TMRE Public Meeting

November 8th, 2017 • Teleconference

- Opening Remarks
- Industry responses to a subset of NRC technical questions (ML17235B148) regarding NEI 17-02, Revision 0
 - Robust Targets/Missiles
 - Target Characteristics
 - Missile Inventory
- Path forward

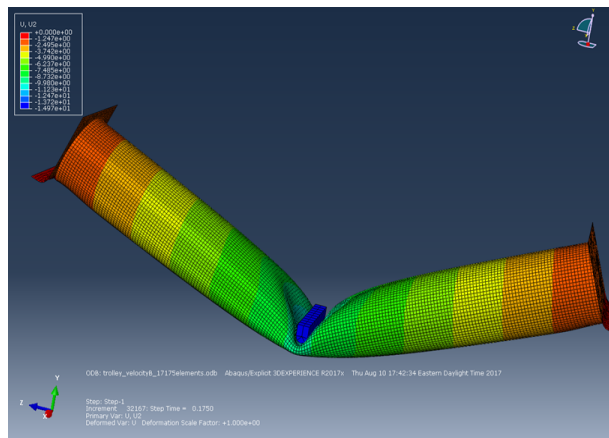
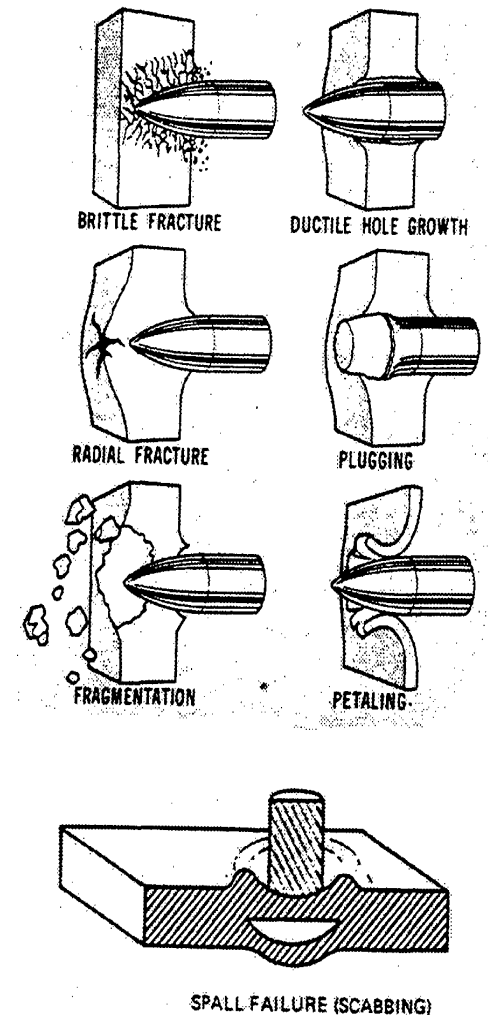
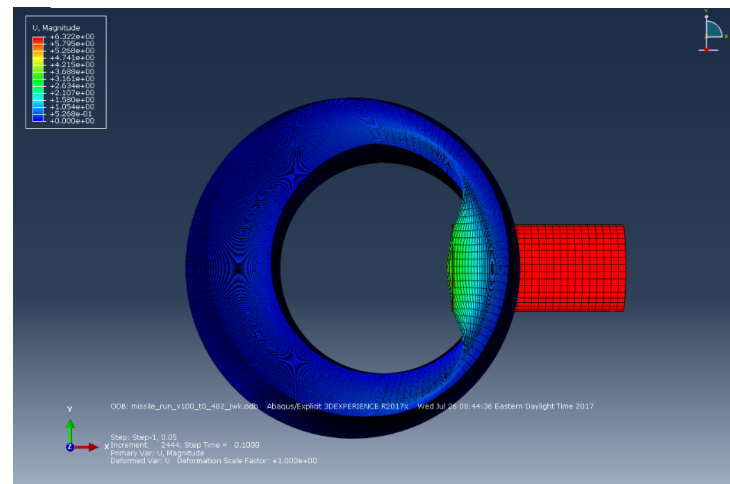
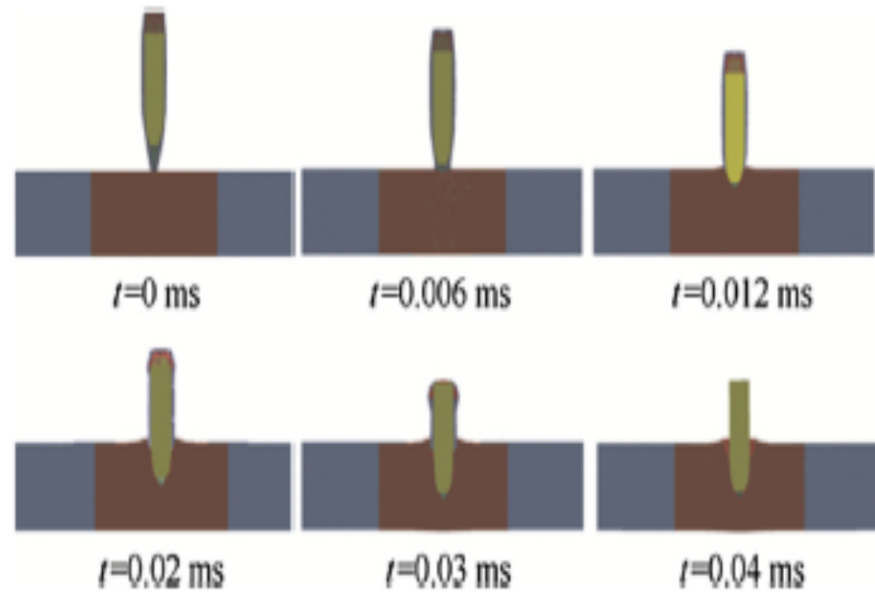
- The assumption that only steel missiles are capable of perforating steel targets, should be verified and a justification provided. Also, in the associated reference document that describes the equation above, it is said that the thickness of the steel barrier required to prevent perforation should exceed the thickness for threshold of perforations by 25 percent. It should be considered whether this assumption is significant enough to be added.

- Appendix C approach addresses both local and global effects on steel targets
- Local effects relate to penetration and deformation failures
 - Penetration failure is assessed using BRL equation (empirical)
 - Deformation failure is assessed using a mechanics-based approach
- Global effects are related to larger deformations

- Penetration into a steel plate requires the missile to have a high areal density and strength to remain intact (e.g., steel-jacketed lead)
- DOE Standard 3014-96 recommends only using BRL equation for rigid missiles
- Thus, for assessing penetration failure, only steel missiles are considered
- However, all missiles are considered credible for deformation failure modes

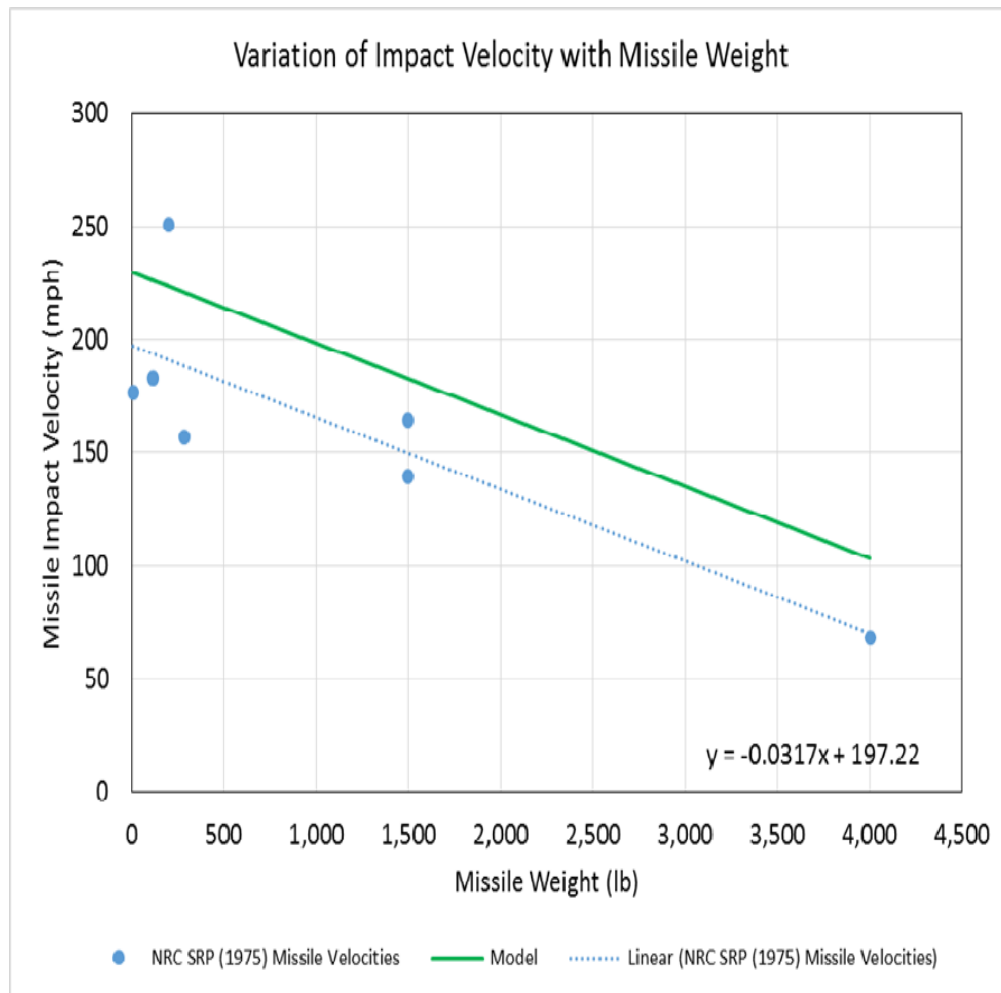
- On the Variation of Impact Velocity with Missile Weight (Figure C-3) plot provided shows how missile velocity assumed in this analysis varies with weight. The equation of the line provided represents the best fit line for the data (blue dotted line), but the model uses the green line, which is conservatively shifted up to a maximum velocity of 230 mph. The guidance should include the equation of the line for the green line in order to calculate any missile velocity given missile weight or vice versa.

Report will be updated to better describe green line relationship as used in the model:

$$V_i(W) = -0.0317W + 230.0$$

Use of Table C.6 Results to Create Table B-14

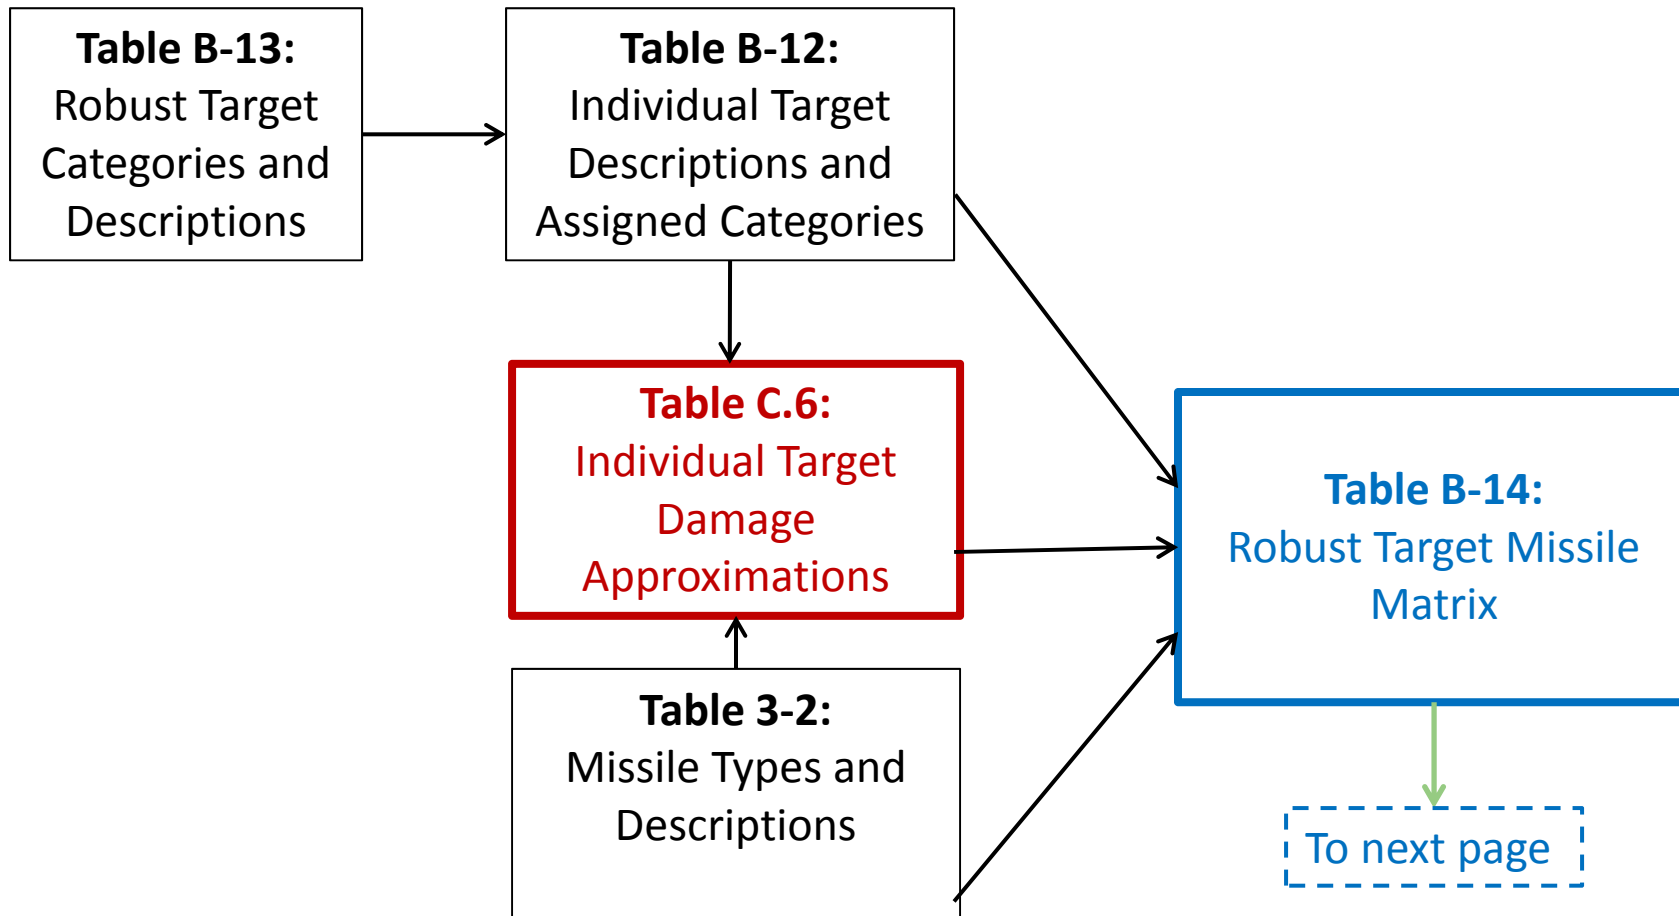
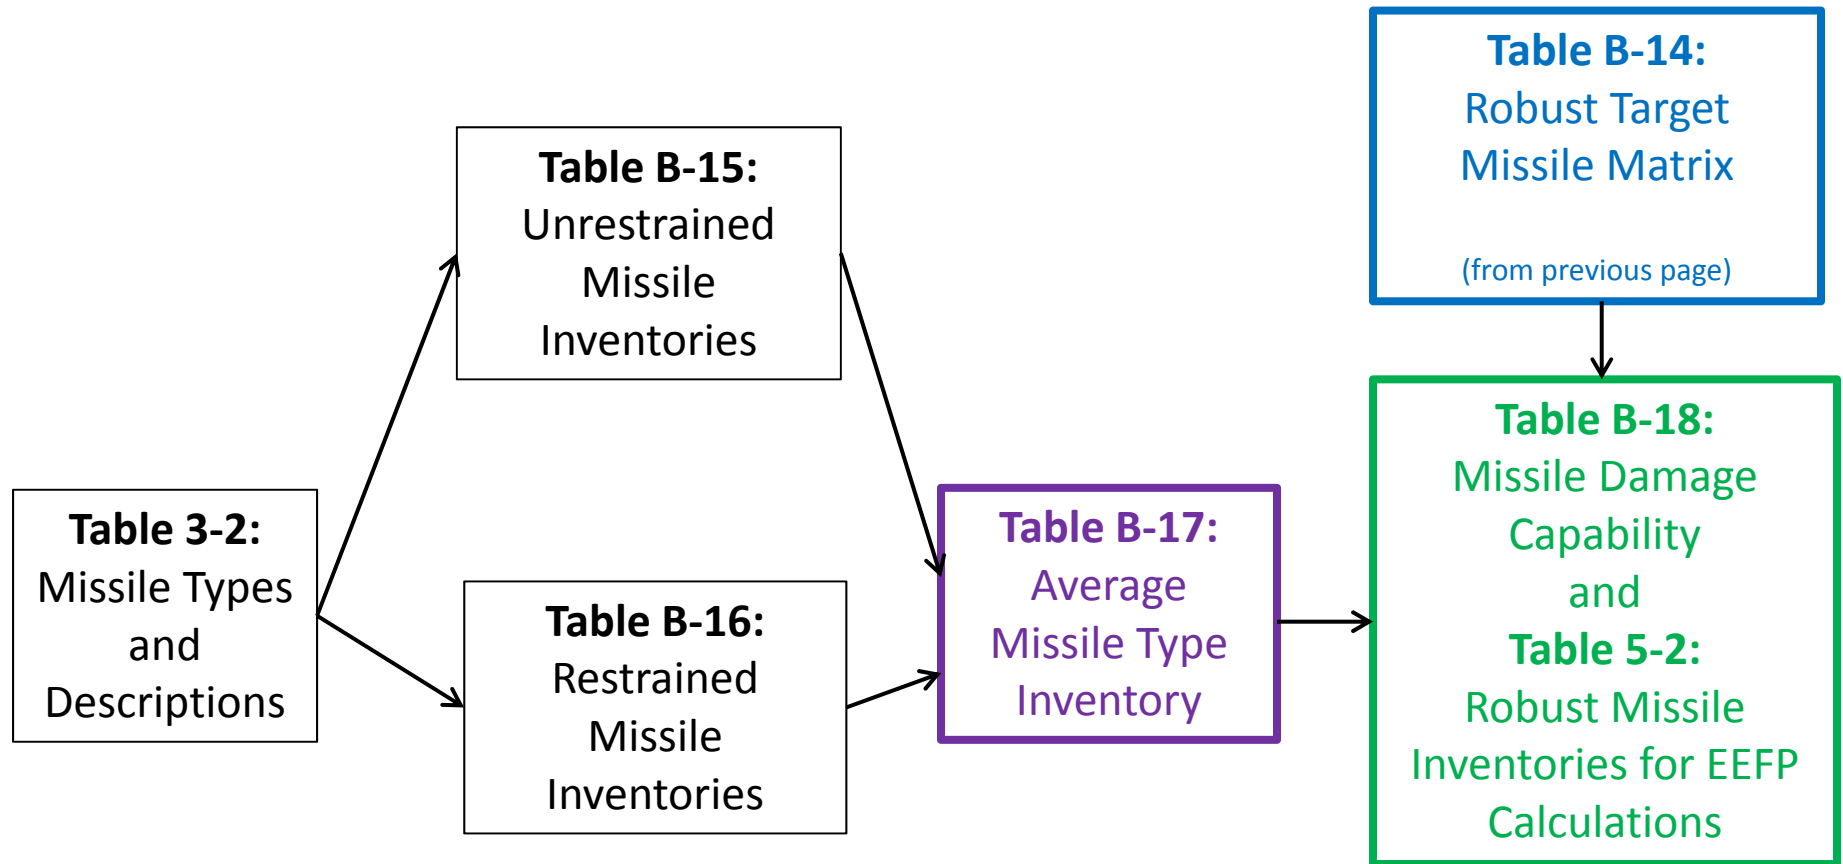
- These comments refer to the development of Tables B-14 and B-18
 - Table B-14: Robust Target Missile Matrix
 - Matrix showing which missile types can damage which robust target category
 - 23 missile types (1 - 23) vs. 9 target categories (A – I)
 - Table B-18: Missile Damage Capability
 - Provides percentage of total missiles that can damage each robust category (A – I)
 - Results repeated in Table 5-2
- Tables B-14, B-18, and others in Appendix B, were updated in NEI 17-02, Rev. 1
- Table C.6 (Target Damage Approximations) has been updated but was not reflected in NEI 17-02, Rev. 1.

- Category B: Steel Pipe
 - At least 16" diameter and thickness less than 3/8" but at least 0.125"
 - Crushing/Crimping of > 50%
- Table C.6 worst case results – damaged by all missiles except: 1, 11, 13, 15, 20

- From Table B-17, sum of missile percentages (excluding 1, 11, 13, 15, 20) is **53%**
 - Majority of missiles contributing to total are: 3" pipes, metal siding, channel sections and trees (42%)
 - Other damaging missiles have relatively small inventories at sites
- Table B-18 for Category B:
 - Calculated percentage = **53%**
 - Final percentage rounded up to **55%**
- Table 5-2 for Category B: **55%**
